## **STAFF REPORT AND RECOMMENDATION TO THE DESIGN COMMISSION**

CASE FILE: LU 15-248782 DZM  
PC # 15-232430  
***NW 19<sup>th</sup> & Quimby Apartments***  
REVIEW BY: Design Commission  
WHEN: January 21, 2016 at 1:30 PM  
WHERE: 1900 SW Fourth Ave., Room 2500A  
Portland, OR 97201

WEST ELEVATION C26

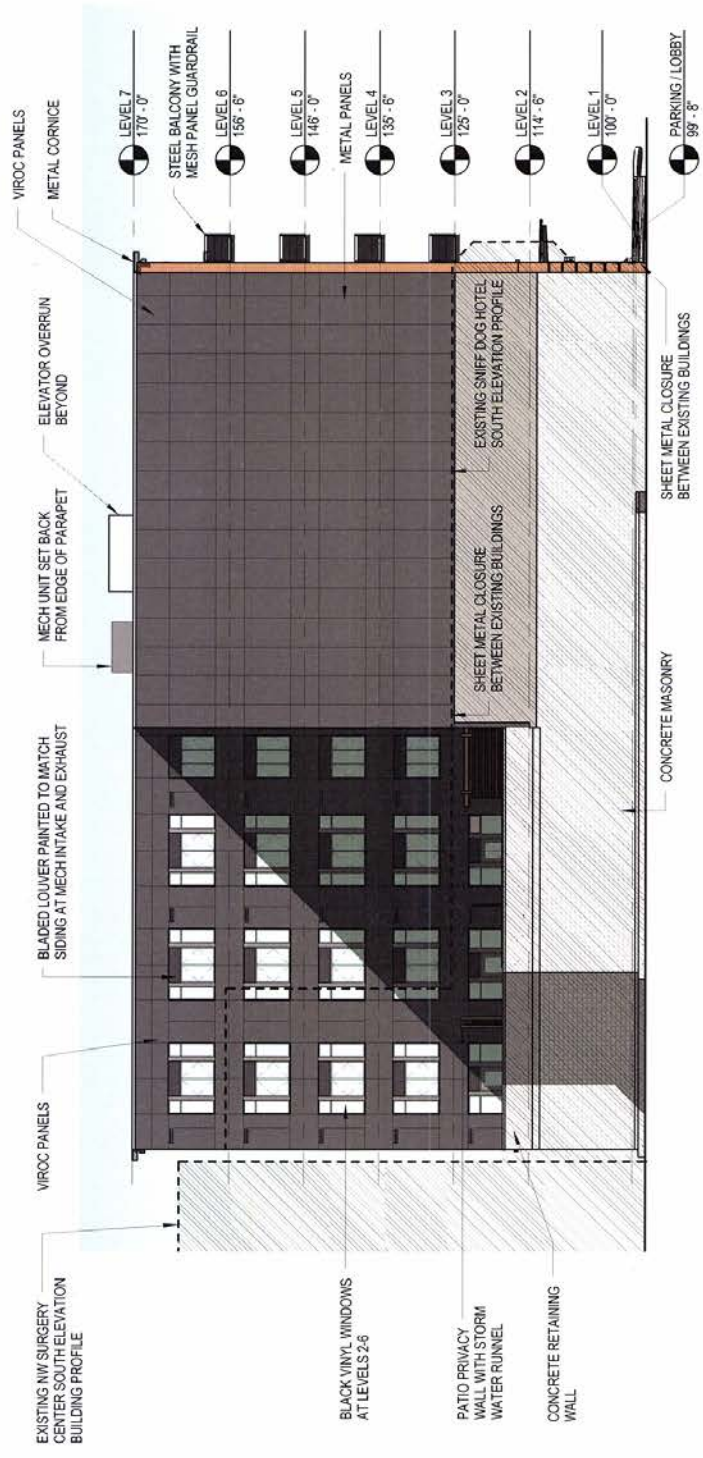
- North end wall – The north end wall will be the most exposed of the two end wall conditions given the 2-story building that exists to the north. More articulation or interest on this large façade is needed. Additionally, NW 19<sup>th</sup> is one-way south, which makes the north end wall much more prominent.

- Transformer – BDS staff does not support the current location of the transformer in the ground floor just south of the garage entry on the NW 19<sup>th</sup> façade. The applicant is working with Transportation through the Design Exception process to relocate the transformer in a vault within with the sidewalk. BDS and PBOT staff are optimistic about the below-grade location and will continue to work with the applicant and utility company to relocate the transformer and extend the active ground floor uses to the north.

- Garage door – While the perforated garage door does help screen the parking within the garage, the finish and detailing could better complement the building components. If perforated necessary for ventilation detailing inspired from the mesh balcony railing could be considered, for example.
